The Commission has issued the enclosed Amendment Nos. **61** and **55** to Facility Operating License Nos. DPR-42 and DPR-60 for the Prairie Island Nuclear Generating Plant, Unit Nos. 1 and 2, in response to your application dated September 14, 1982.

The amendments revise the Technical Specifications (TS) concerned with Steam Generator Tube Surveillance, Steam Exclusion System, Auxiliary Feedwater System reporting requirements, Administrative Controls, and correct typographical errors.

PRAIRIE ISLAND NUCLEAR GENERATING PLANT UNIT NO. 1

SAFETY EVALUATION BY THE OFFICE OF NUCLEAR REACTOR REGULATION
RELATED TO AMENDMENT NO. 61 TO FACILITY OPERATING LICENSE NO. DPR-42
AND AMENDMENT NO. 55 TO FACILITY OPERATING LICENSE NO. DPR-60
NORTHERN STATES POWER COMPANY
PRAIRIE ISLAND NUCLEAR GENERATING PLANT, UNIT NOS. 1 AND 2
DOCKET NOS. 50-282 AND 50-306

FIGURE TS.6.1-1 NSP CORPORATION ORGANIZATION RELATIONSHIP TO ON-SITE OPERATING ORGANIZATIONS

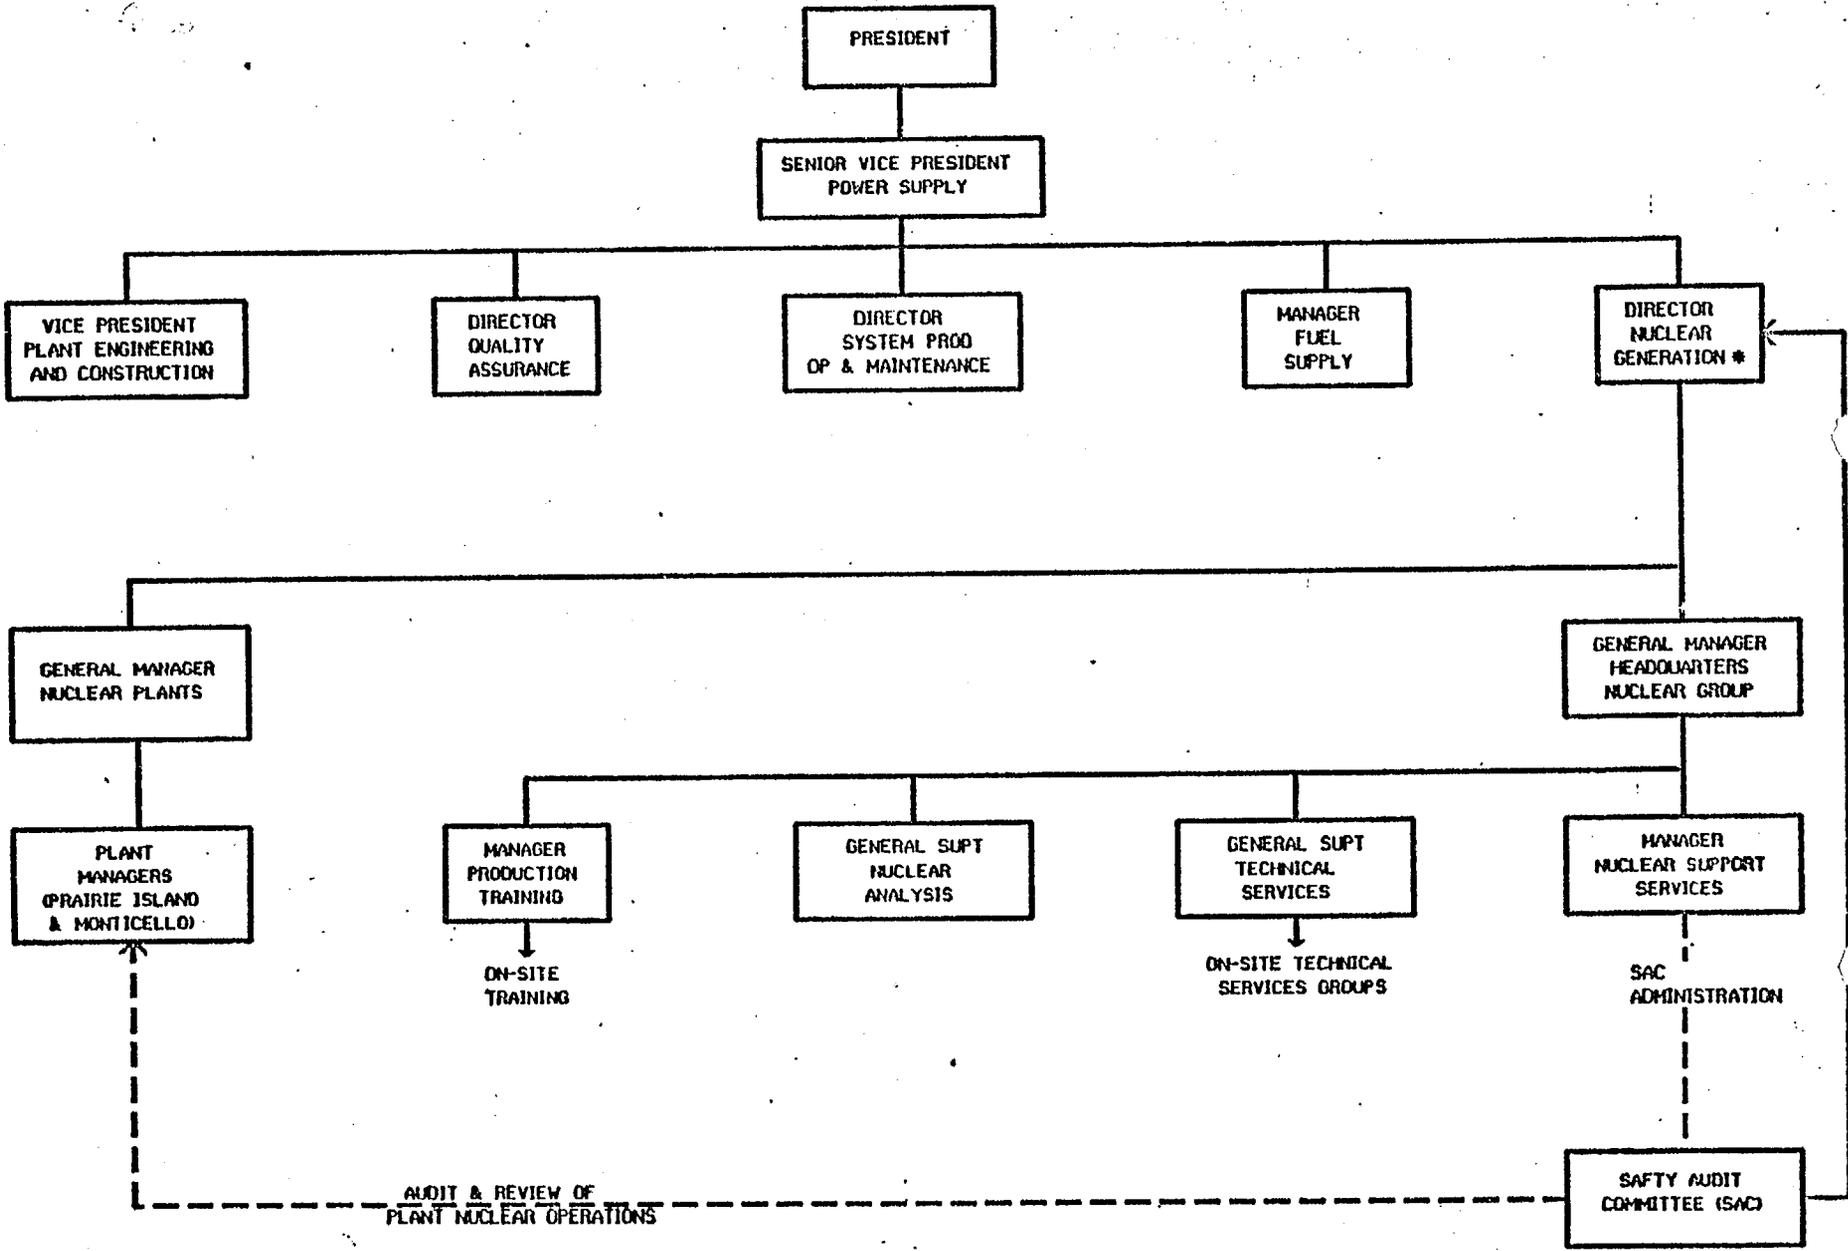
The licensee has proposed to update the NSP Corporate Organization Chart Figure TS 6.1-1 to reflect the recent organization changes. Other changes include position title changes on pages TS 6.2-1, TS 6.2-3 and TS 6.2-5 to reflect title changes of various positions. The licensee requested to replace Figure TS 6.1-2 with a redrawn figure.

Our review of these proposed changes indicates that the responsibilities and resources of the revised organization are essentially unchanged.
